6573A-08

S E R V I C E N O T E

6573A DC POWER SUPPLY, 0-35 V, 0-60 A, 2100 W. MANUALLY CONTROLLED.

The **AC INPUT SAFETY COVER** has a strain relief used to secure the AC line cord that may become loose.

Figure 3 Regal Non locking Nut

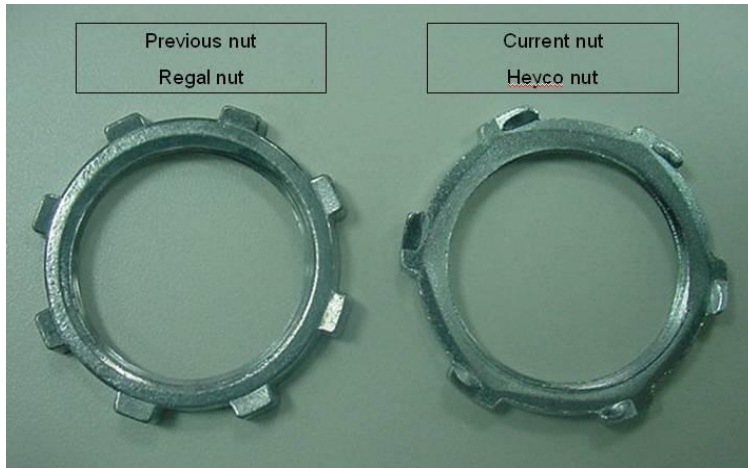
Figure 2 shows the inside of the AC Safety Cover housing the incorrect hardware is shown. It will be very difficult to tighten the strain relief. AMC (Asian Manufacturing Center) uses a special tool to tighten the locking nut. When the incorrect nut is used or a locking Nut is put on incorrectly the strain relief will become loose as described above.

Figures 3 & 5 is representative of a not without locking ribs.

The entire AC **INPUT SAFETY COVER** P/N 5040-1676 should be replaced.
